Index 102-603

Two-Lane, Two-Way, Work Within the Travel Way

COMMENTS AND RESPONSES

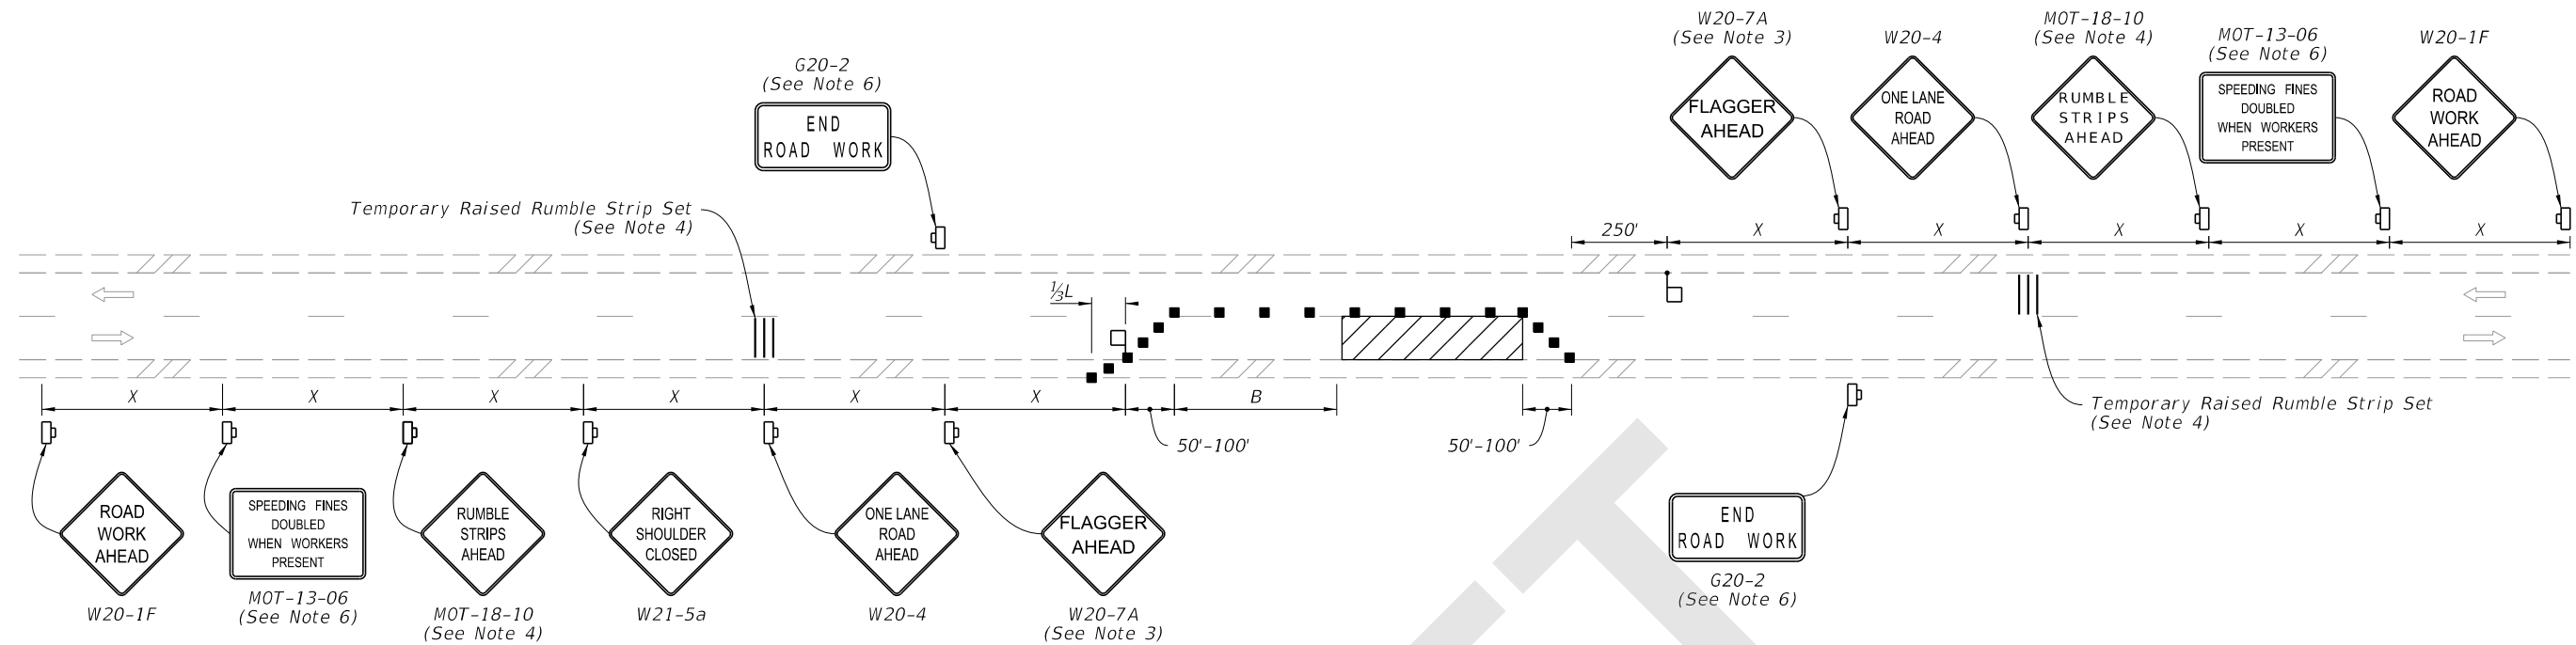
COMMENT: 102-603 (and other index): The taper length of the channelization portion in front of the flagger is given a length of 50' to 100'. This also was done in past standards. Please consider provide guidance of when to use 50' and when to use 100'.

RESPONSE: *MUTCD guidance considers a taper between 50 and 100 feet to be relatively short, yet sufficient for guiding traffic into a one-lane section controlled by a flagger or temporary signal. No additional guidance is given.*

No Change

LAST REVISION 11/01/20	REVISION	DESCRIPTION:	FY 2021-22 STANDARD PLANS	TWO-LANE, TWO-WAY WORK WITHIN THE TRAVEL WAY	INDEX 102-603	SHEET 2 of 2
---------------------------	----------	--------------	------------------------------	---	------------------	-----------------

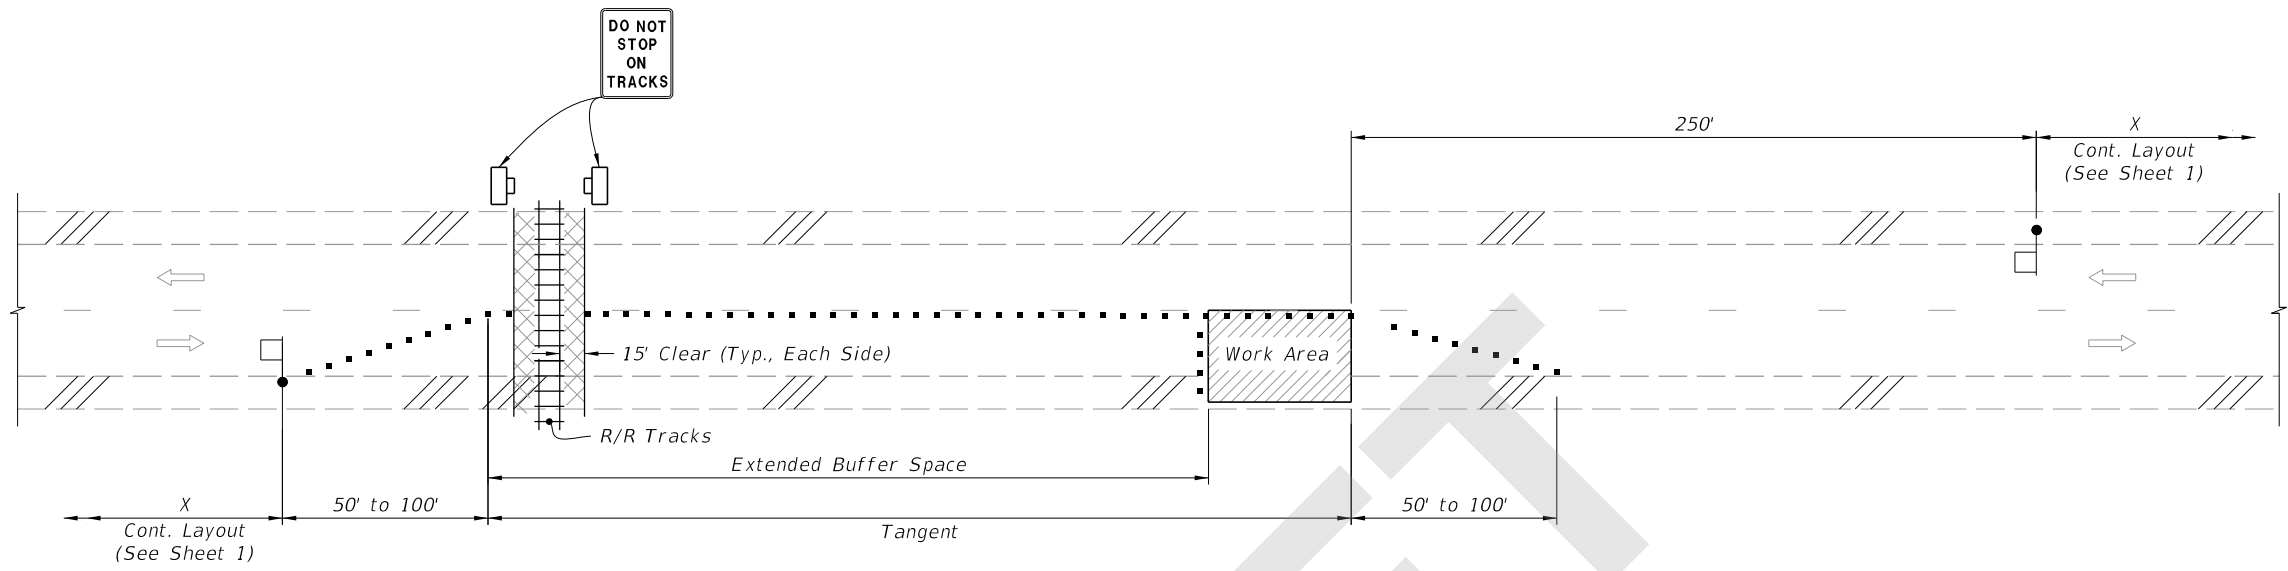
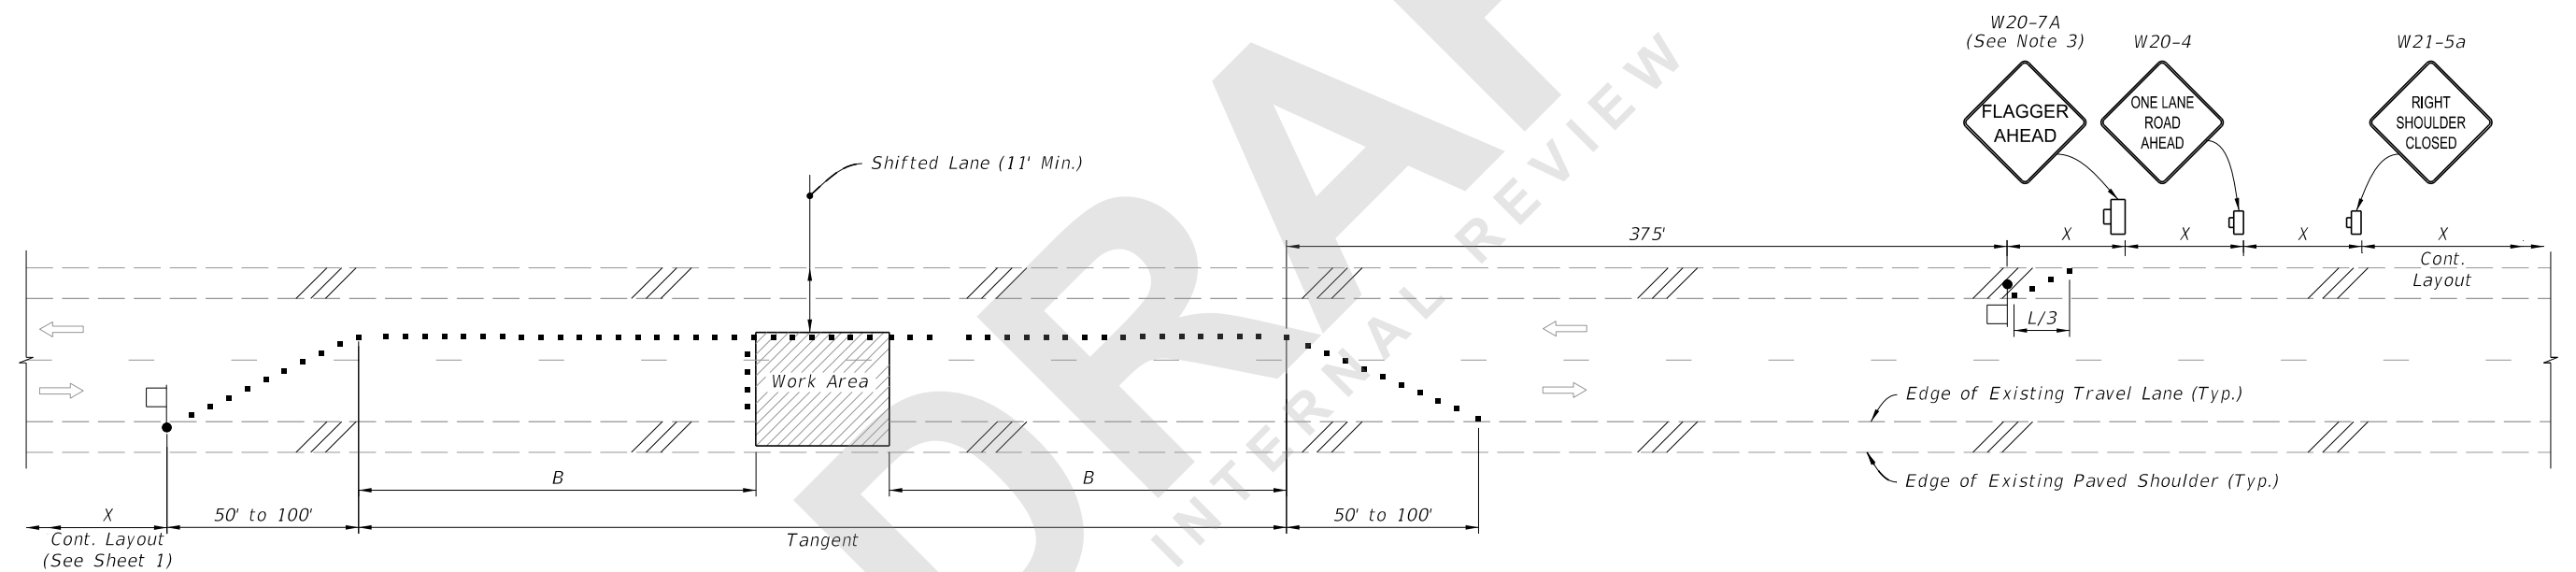
COMMENT: Sheet 2: Upstream of flagger on both details has a label "Cont. Layout" I am assuming this is for the upstream signs but I do not see where it gives a note of where to look for the information.

RESPONSE: *Agreed, the intent is to continue with the signage and spacings from Sheet 1.*

Change Made: *Call-outs revised for clarity.*
